Publication 72M  
June 2010 Edition  
Change No. 1

**Standards for Roadway Construction, RC 1M-100M  
June 2010 Edition  
Change No. 1**

STANDARDS FOR ROADWAY CONSTRUCTION  
SERIES RC-1M TO 100M

PDT Pub #72M

**CURB RAMPS AND SIDEWALKS  
NEW CONSTRUCTION OR  
ALTERATION DETAILS  
PUSHBUTTONS, TRIANGULAR LEVEL  
AREA, CHANGE OF GRADE AND CROSS  
SLOPE TRANSITIONS**

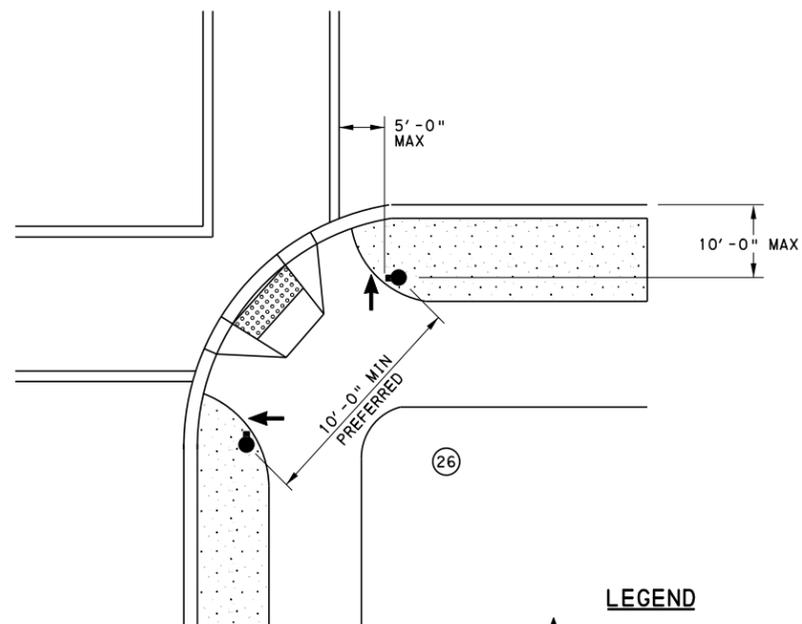
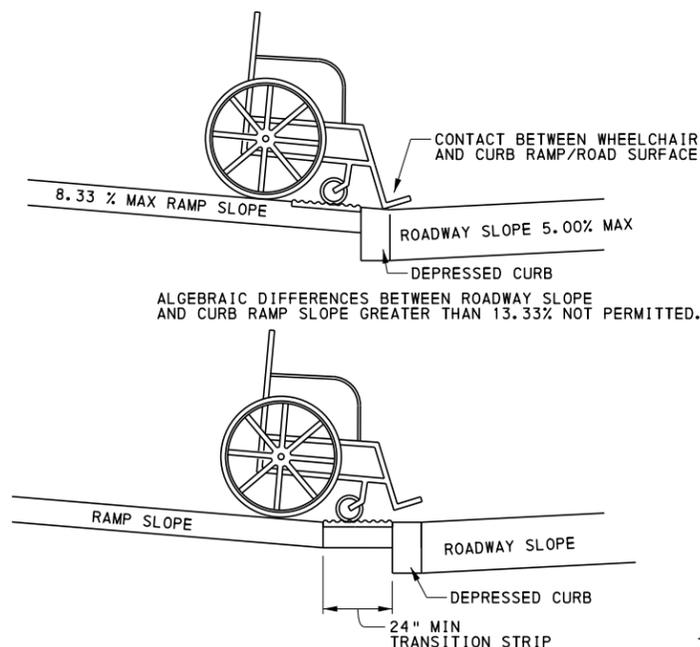
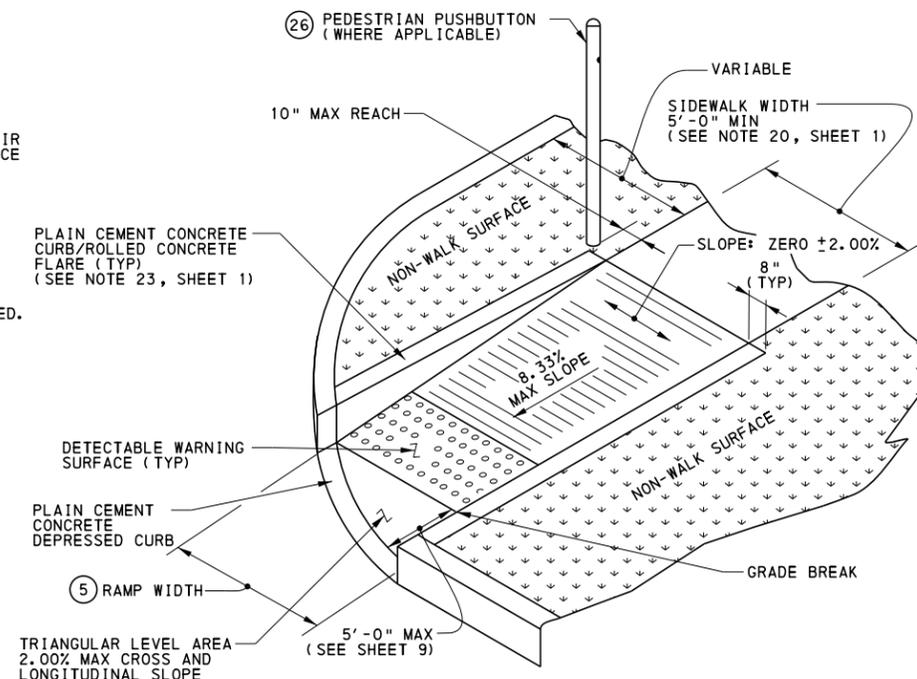
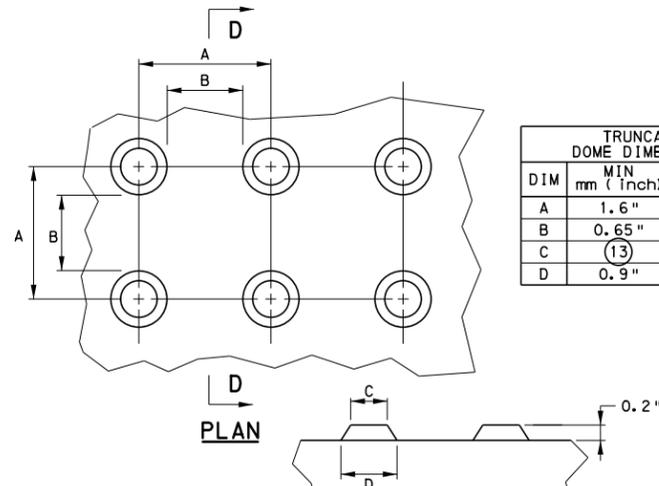
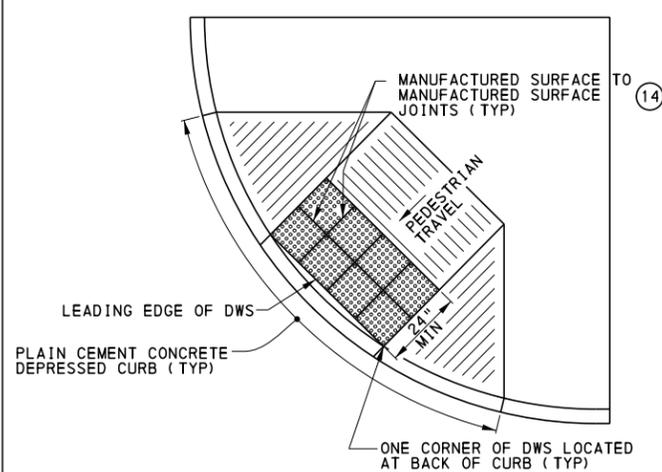
RC-67M

Sheet 8

Revised title from "PUSHBUTTONS / TRIANGULAR LANDING" to "PUSHBUTTONS, TRIANGULAR LEVEL AREA, CHANGE OF GRADE AND CROSS SLOPE TRANSITIONS".

Deleted Pedestrian Pushbutton Detail detail.

Deleted Pedestrian Push Button Dual Sign Mounting Detail Plan View detail.

Added Ramp Cross Slope Transition to Match Roadway Profile Slope detail.

For Recommended Pushbutton Locations details:

\*Moved pedestrian pushbuttons off the sidewalk and onto the non-walk surface.

\*Adjusted the dimension 10'-0" MAX to be measured from the front face of curb to the pedestrian pushbutton located in the non-walk surface.

For Change of Grade Limitations detail:

\*Revised algebraic difference between roadway slope and curb ramp slope from 11.00% to 13.33% (2 locations).

\*Revised value that transition strip slope is not to exceed from 2.00% to 5.00%.

\*Deleted "8.33% MAX" before "RAMP SLOPE" to the left of the 24" minimum transition strip.

\*Deleted "5.00% MAX" after "ROADWAY SLOPE" to the right of the 24" minimum transition strip.

For Triangular Level Area for Directional Ramps on Curb Returns detail, added Note 26 with pedestrian pushbutton.

Deleted Note 27.

NEW CONSTRUCTION OR ALTERATION DETAILS  
 DETECTABLE WARNING SURFACE

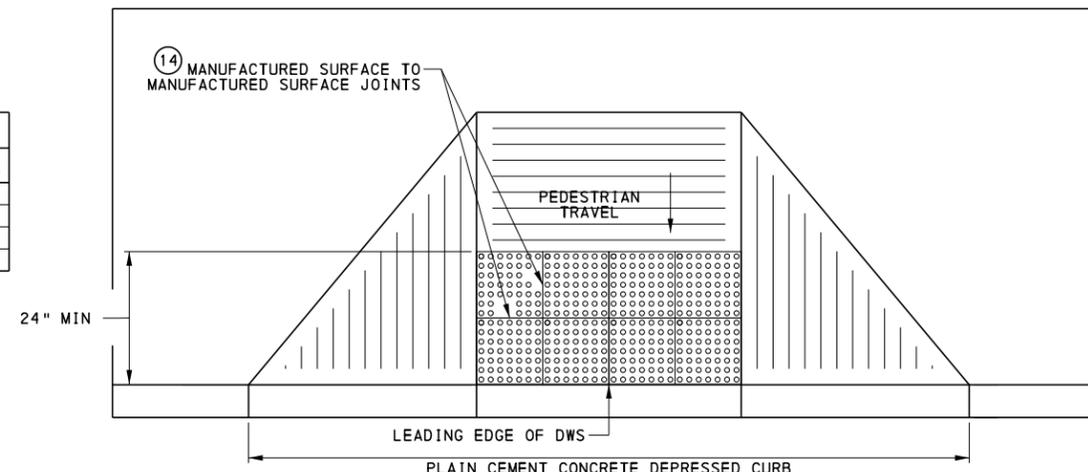
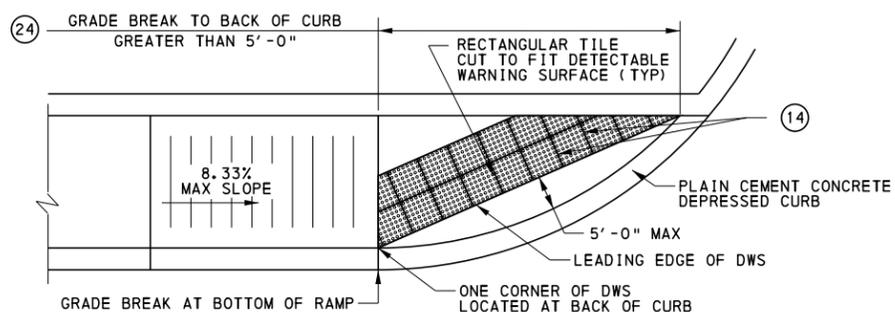
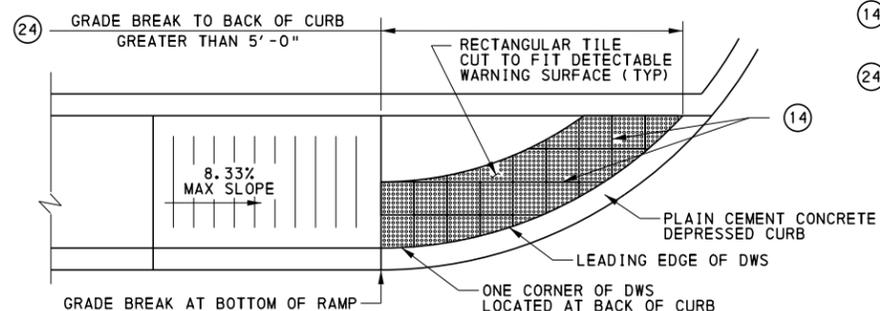
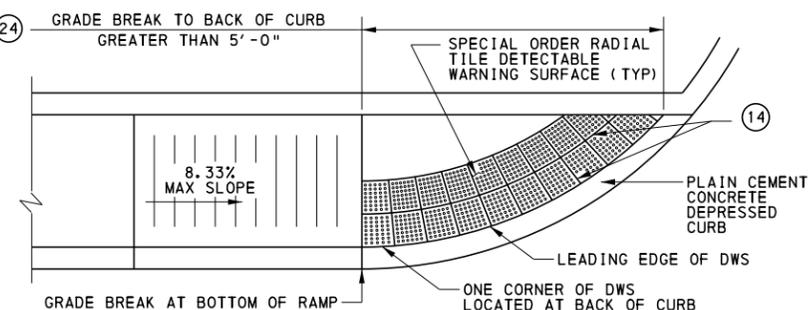
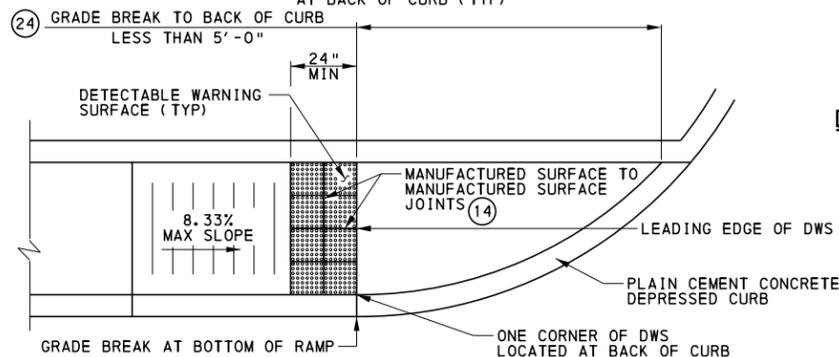
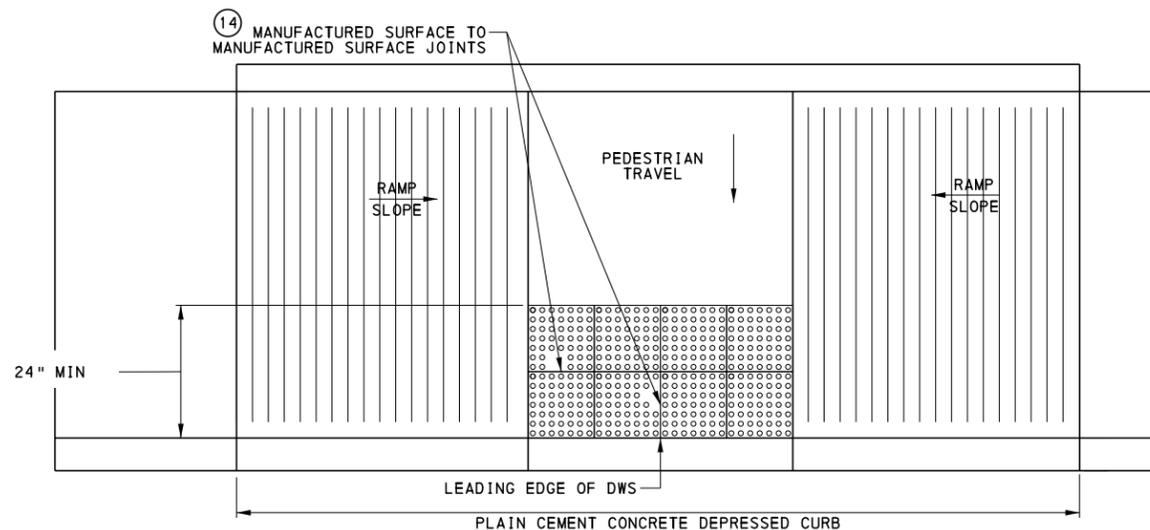
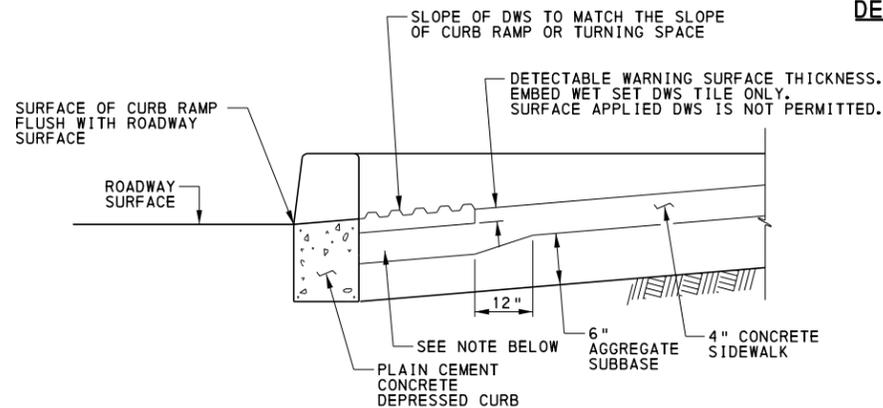
RC-67M

Sheet 9

For Detectable Warning Surface (DWS) on Curved Surfaces detail:

\*In top graphic (diagonal ramp), deleted Note 24.

\*Added bottom graphic with rectangular tile positioned on a skew relative to the 8.33% maximum slope.

\*In four lowest graphics, revised wording beside reference to Note 24 to indicate "GRADE BREAK TO BACK OF CURB", with one distance "LESS THAN 5'-0" " and three distances "GREATER THAN 5'-0" ".

\*In three lowest graphics, indicated whether detectable warning surface is a "SPECIAL ORDER RADIAL TILE" or a "RECTANGULAR TILE CUT TO FIT".

For Detectable Warning Surface (DWS) on Type 1 Curb Ramp detail and Detectable Warning Surface (DWS) on Type 2 Curb Ramp detail, in lower right corner:

\*Deleted reference to Note 24.

\*Deleted 8" maximum dimension from one corner of DWS to face of curb.

For Detectable Warning Surface Embedding Detail detail:

\*After "DETECTABLE WARNING SURFACE THICKNESS", added two sentences to embed wet set DWS tile only and to indicate surface applied DWS is not permitted.
